FORD CD4E TURBINE SHAFT SPEED SENSOR MOUNTING SURFACE ON PUMP BODIES INCORRECT

Figure 2

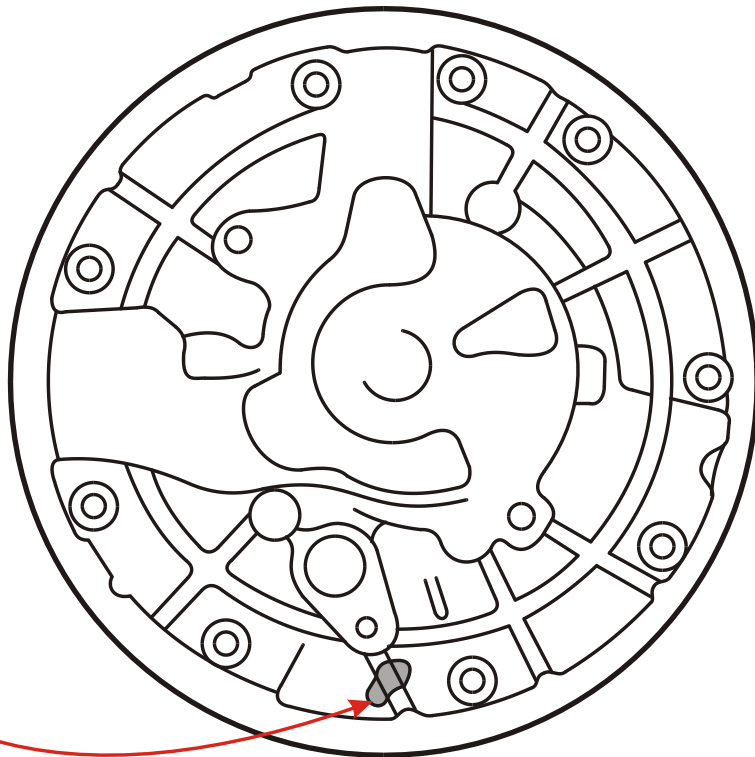
Some 1995 Contour, Probe and Mystique vehicles equipped with the CD4E transaxle, built from December 1994 through February 1995 with serial numbers 43350467 to 43370105 and 43410230 to 43420326 may have been assembled with incorrect turbine shaft speed sensor mounting surfaces on the pump bodies. The Turbine Shaft Speed Sensor (TSS) was modified to allow the TSS sensor to seat properly on these pump bodies. These TSS sensors were identified with a "Yellow" paint dot on the sensor itself in the location shown in Figure 2. The mis-machined pump bodies were identified with an "Orange" dot on the pump bodies in the location shown in Figure 2.

ORANGE DOT OF PAINT
PLACED HERE FOR I.D. ON
MIS-MACHINED PUMP BODIES

When servicing these units and TSS Sensor and/or Oil Pump assembly replacement is necessary, it will be mandatory that both pieces be replaced to prevent a clearance concern between the pump body and the Turbine Shaft Speed Sensor.

Oil Pump Assembly	F4RZ-7A103-A
Turbine Shaft Speed Sensor	F3RZ-7M101-A
